# FORESTSIDE TOWNHOUSES

## TENDER ADDENDUM # 1

Date: August 28<sup>th</sup>, 2019.

JAP Project No: 19066

Date Plotted:	ND	Date:	Aug 28 2019
Drawn By:	JW	Scale:	1 : 100
Checked By:	JW	Revision Number:	
Job No.:	19066	Sheet No.:	S-102A

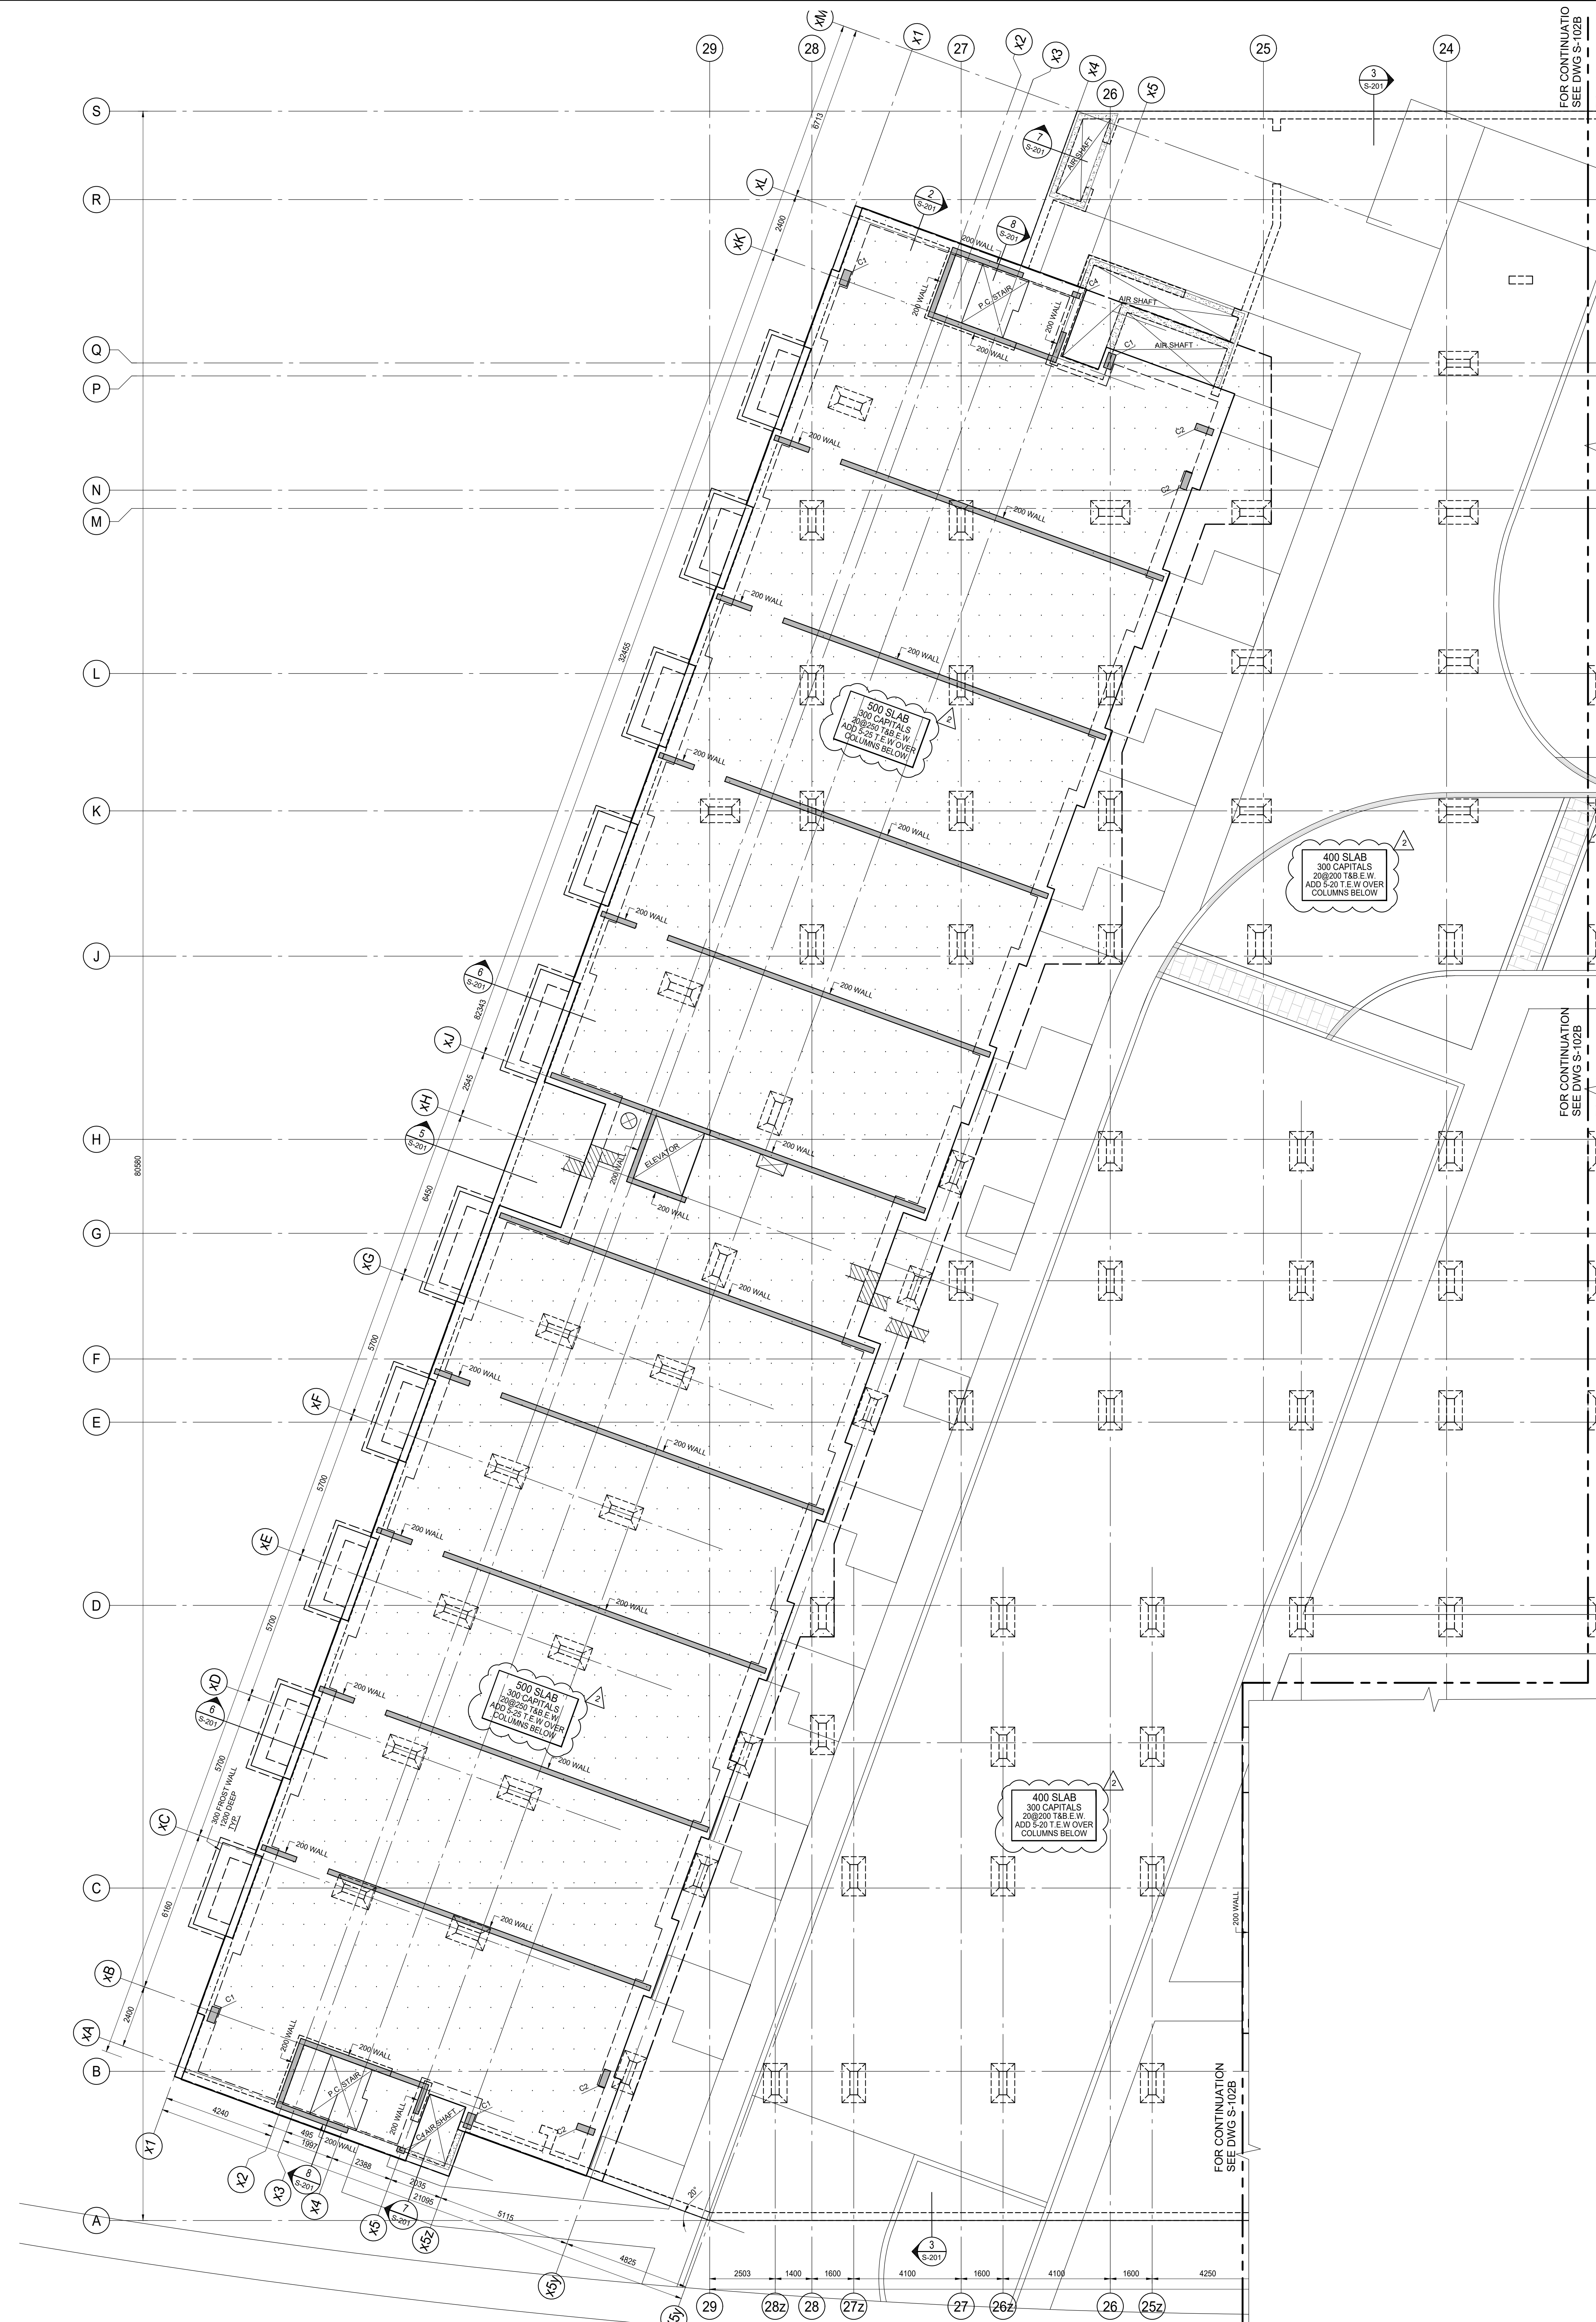
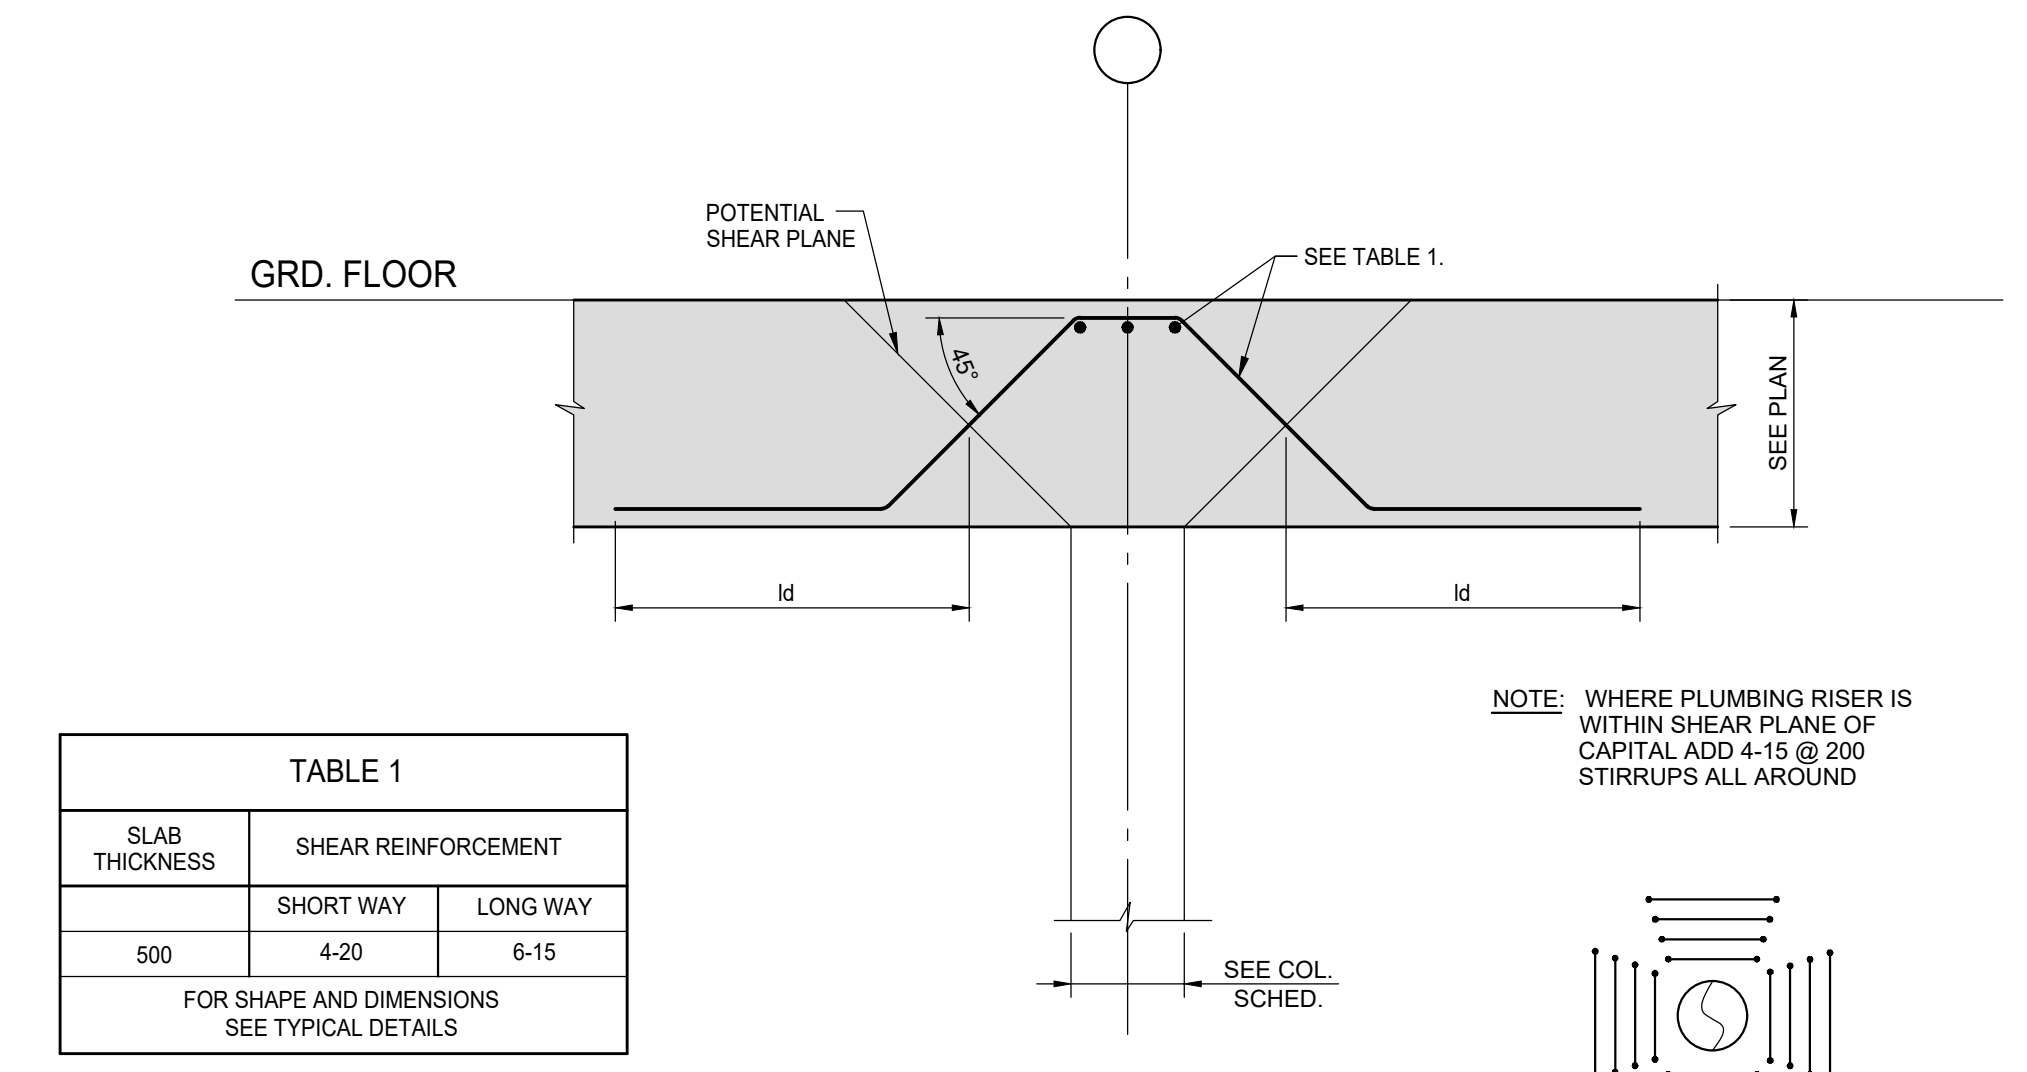
- 1.1 **Refer to Drawing S-102A & B “Ground Floor Framing Plan”**
  - a) Deleted duct bank
  - b) Added rebar information for GF slab
- 1.2 **Refer to Drawing S-103A & B “2<sup>nd</sup> Floor Framing Plan”**
  - c) Added rebar information for 2nd floor slab
- 1.3 **Refer to Drawing S-104A & B “3<sup>rd</sup> Floor Framing Plan”**
  - d) Added rebar information for 3<sup>rd</sup> floor slab
- 1.4 **Refer to Drawing S-105A & B “4<sup>th</sup> Floor Framing Plan”**
  - e) Added rebar information for 4<sup>th</sup> floor slab
- 1.5 **Refer to Drawing S-106A & B “Roof Framing Plan”**
  - f) Added rebar information for Roof slab
- 1.6 **Refer to Drawing S-251 “Floor Sections”**
  - a) Deleted 3/S-251
- 1.7 **Refer to Drawing S-301 “Schedules”**
  - b) Updated rebar information for mat footings
